# Access Compliance Report

## Public Rights-of-Way

### (Curb Ramps)

Intersection ID: 27236	Main Street: BALLANTYNE CORPORATE PL	Cross Street: BRIXHAM HILL AV	Location: SW
ADA ID: 9E8460C2C811	Ramp Type: Perp	Initial Pass/Fail: Fail	Overall Compliance: No
Severity Score: 13.75			
Codes/Mitigation Info/Possible Solution		Field Measurements/Component Compliance

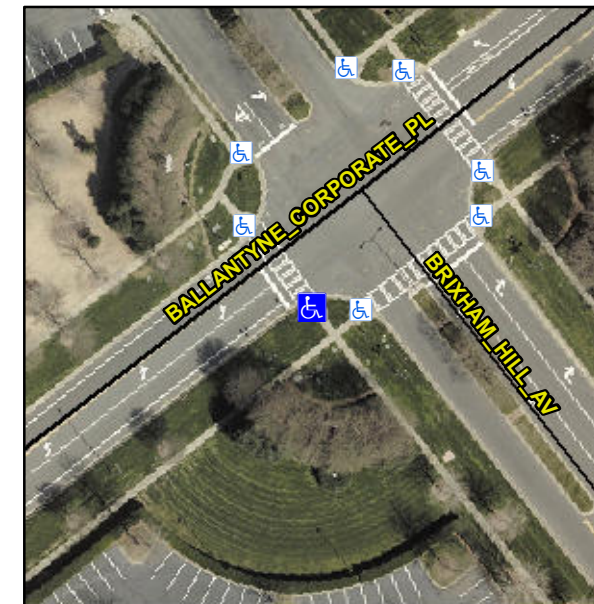
**R304.2.2, R304.5.3**

Compliance	Description	Data	Compliance	Description	Data
N/A	Ramp Length (in)	93.0	No	Ramp Slope (%)	11.7
Yes	Ramp Width (in)	48.0	No	Ramp XSlope (%)	2.6
N/A	Flare Type LT	N/A	N/A	Flare Type RT	N/A
N/A	Flare Slope LT (%)	N/A	N/A	Flare Slope RT (%)	N/A
N/A	Flare Traversable LT?	N/A	N/A	Flare Traversable RT?	N/A
N/A	Landing Length (in)	N/A	N/A	DWS Provided?	N/A
N/A	Landing Width (in)	N/A	N/A	DWS Contrast?	N/A
N/A	Landing Slope (%)	N/A	N/A	DWS Length (in)	N/A
N/A	Landing X Slope (%)	N/A	N/A	DWS Full Width?	N/A
N/A	Landing Curb? (Y/N)	N/A	N/A	DWS Offset (in)	N/A
N/A	Shared Landing?	N/A			
N/A	Gutter Ponding?	N/A	N/A	Gutter Slope (%)	N/A
N/A	Gutter Lip Ht (in)	N/A	N/A	Gutter X Slope (%)	N/A
N/A	Painted X Walk1?	Yes	N/A	Painted X Walk2?	N/A
	X Walk 1 Direction	To NW		X Walk 2 Direction	N/A
N/A	X Walk 1 Width (in)	110.0	N/A	X Walk 2 Width (in)	N/A
	X Walk 1 Slope (%)	3.6		X Walk 2 Slope (%)	N/A
	X Walk 1 X Slope (%)	0.5		X Walk 2 X Slope (%)	N/A

**Remove & Replace Entire Ramp.**
